**CITY OF VANCOUVER  
DEVELOPMENT, BUILDINGS, & LICENSING**

**DEVELOPMENT PERMIT STAFF  
(DPSC Meeting)  
COMMITTEE MEETING  
February 5, 2025**

**1525 Robson Street (COMPLETE APPLICATION)  
DP-2024-00900 – C-6**

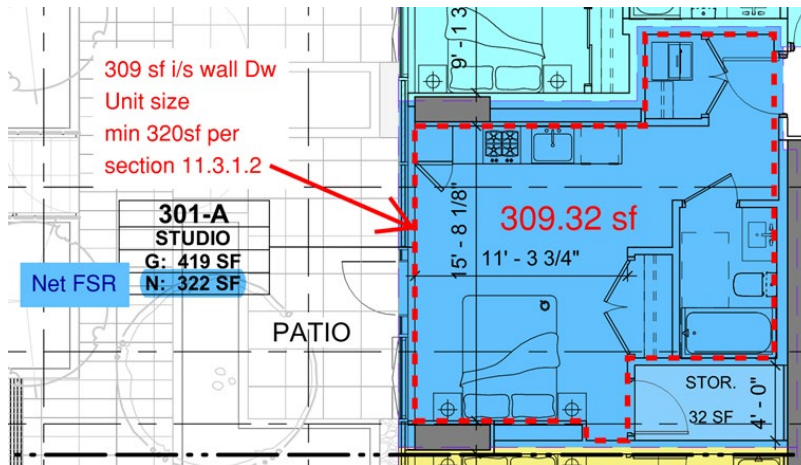
The base overall proposed critical peak height of 292.91 ft is taken to the East Tower Level 29 Amenity Floor Slab (Geo. 350.72) since the following features and floors can be exempted from maximum building height contingent of support from the Development Permit Board. Staff support the following features be excepted from height as permissible by Zoning and Development By-law Section 10.1.1:

- common roof-top amenity structures and floors, in accordance with Section 10.1.1(g), currently proposing approximately 3.5 ft over the base C-6 zone By-law maximum height; and
- mechanical floors, equipment, elevator machine rooms, and related screening materials in accordance with Section 10.1.1(b), currently proposing approximately 29 ft over the base C-6 zone By-law maximum height for these mechanical features.
